**SUBJECT: AP1000 COL Standard Technical Report Submittal of APP-GW-GLR-022, Revision 1
(Technical Report Number 8)**

APP-GW-GLR-022, Revision 1

“AP1000 Leak-Before-Break Evaluation of As-Designed Piping”

Technical Report Number 8

Figure 4-10
High Energy Piping—Passive Core Cooling System
(Revised, DCD Figure 3E-4—Sheet 2 of 2)

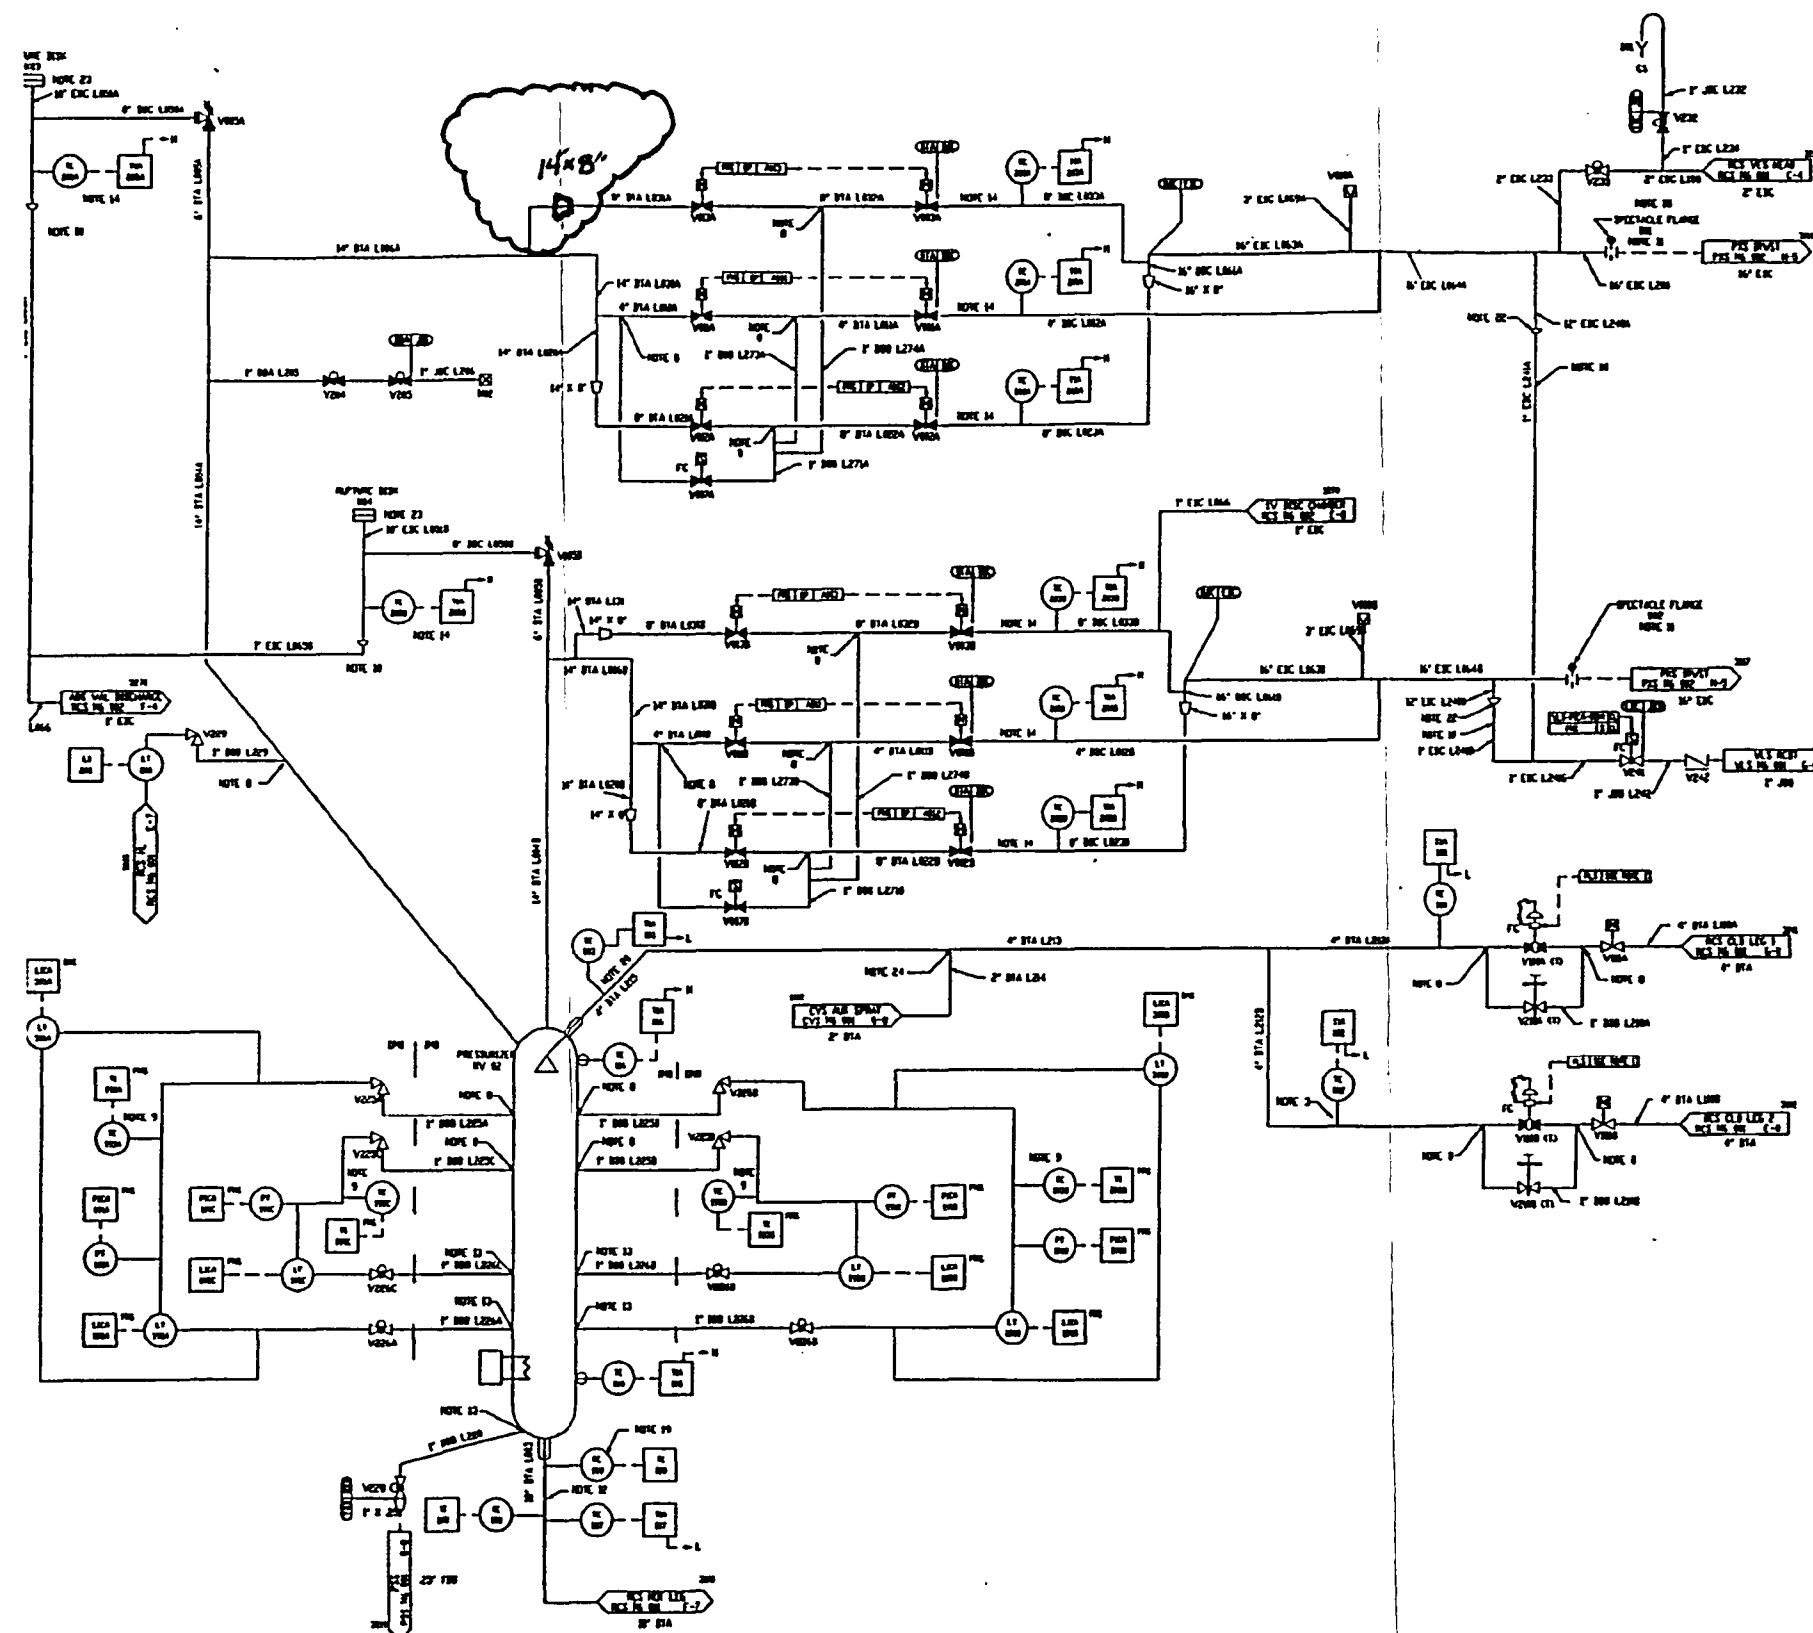
Change as noted in red.

Reactor Coolant System - Piping and Instrumentation Diagram
(Revised, DCD Figure 5.1-5 - Sheet 2 of 3)

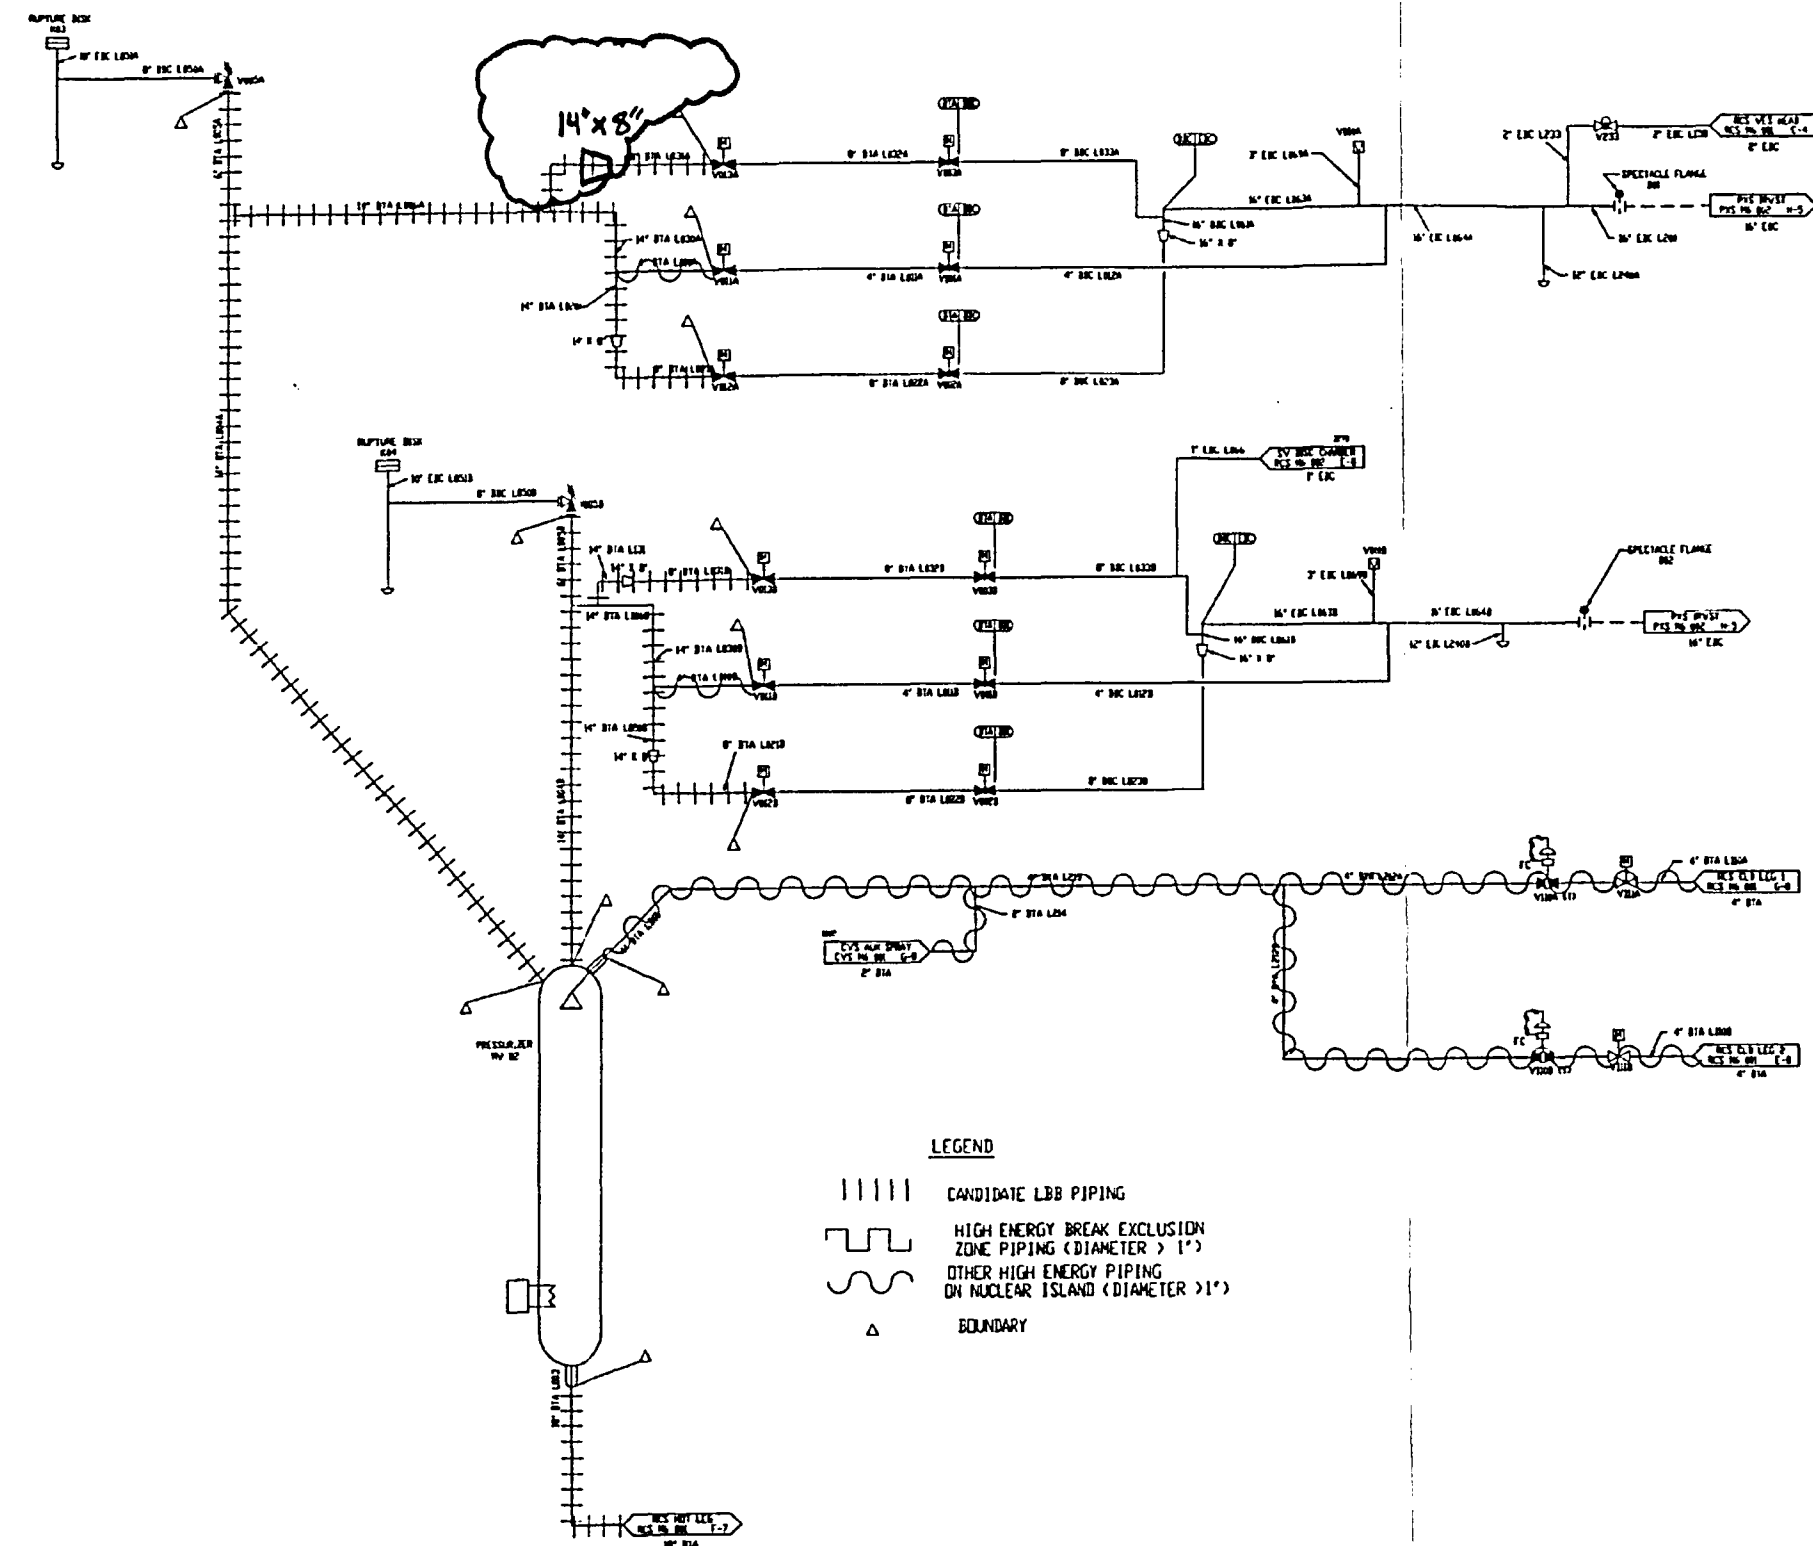
A 14"x8" reducer has been added to line RCS-L031A on the Upper Tier of the ADS 2,3 to make it consistent with the Lower Tier. The Reactor Coolant System-Piping and Instrumentation Diagram (Figure 5.1-5) in DCD Section 5.1 and High Energy Piping –Reactor Coolant System in DCD (Figure 3E-3) Appendix 3E reflect the addition of the reducer.

Change as noted in red.
